NOTICE UNDER SCHEDULE VI CHAPTER XI, RULE 2 (I) OF
THE CITY OF KARACHI MUNICIPAL ACT 1933.

PLAN

SHOWING PROPOSED W.C.

ON PLOT NO 1/1 B.S.R. 6.

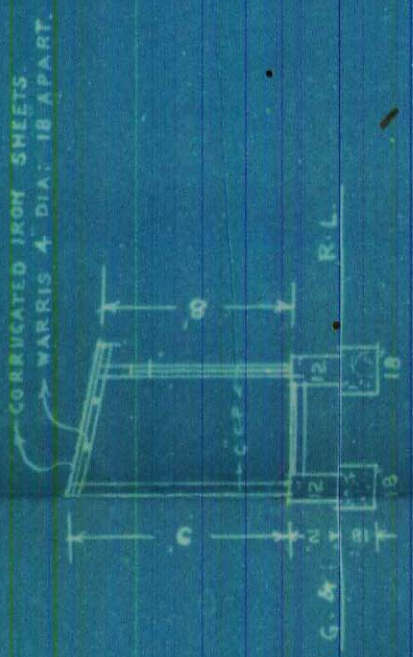
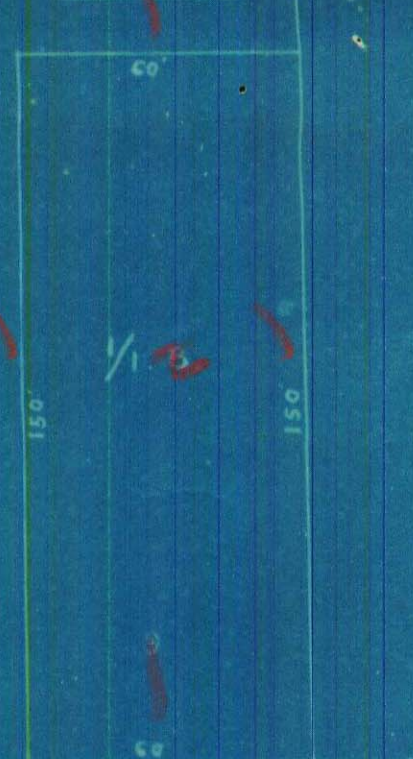
Plot no. is wrong. The correct no. is
1/12 & 8R-6 1/12.

Why. (1) It would be better if the position of the W.C & sink were shifted to the end of the godown, by the side of the motor garage.

not necessary. (2) Cardinal directions may be shown

Pl. ask the Architect
to colour & show the drainage
connections in details.

you are requested to kindly call at the Municipal Office on any
week day except Saturday from 3.30 p. m. to 4.30 p. m. when therequirements of this will be pointed out to you. The plans submitted
require to be coloured and Drainage Connection
details shown.

Man approved - The
architects will please show cardinal
points

1. Plans will be approved subject to your showing
the cardinal points.

With reference to your letter No:
B.S.P 334/35 dated 7th instant we beg to
return the plans after showing cardinal point,
and shall thank you to pass the plan.
